Docket Item # 2 & 3
BAR CASE # 2010-0092, 0093

BAR Meeting
May 19, 2010

ISSUE: Permit to Demolish/Encapsulate & Addition

LOCATION: 415 South Washington Street

Figure 3. North Elevation

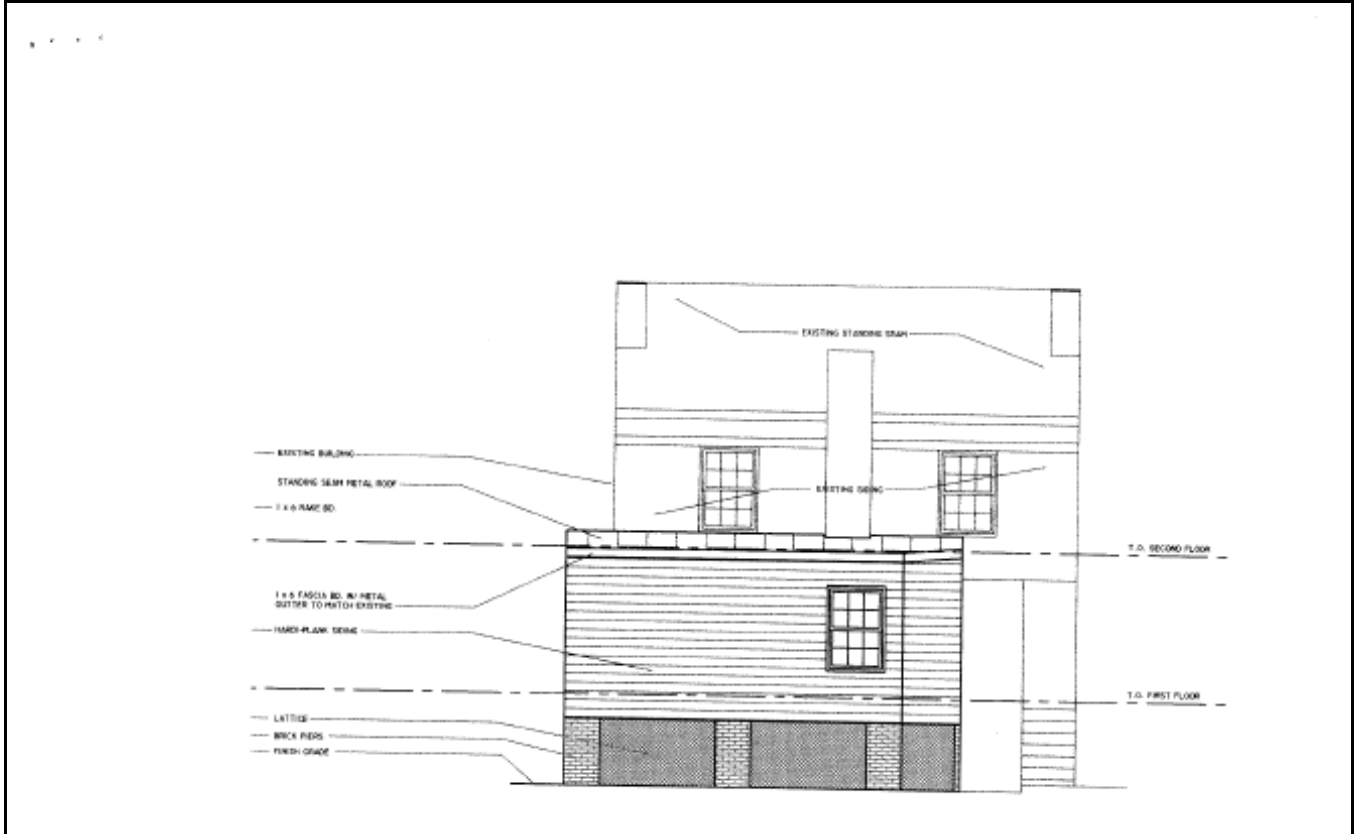
The proposed addition will measure 22 ½ feet wide by 12 feet deep and will be one-story in height, with a gross square footage of approximately 264 square feet. The north elevation of the addition will be devoid of openings and both the rear and south elevation will each have a single six-over-six window. The proposed addition will be elevated to the level of the first floor of the historic main block by brick piers enclosed with wood lattice.
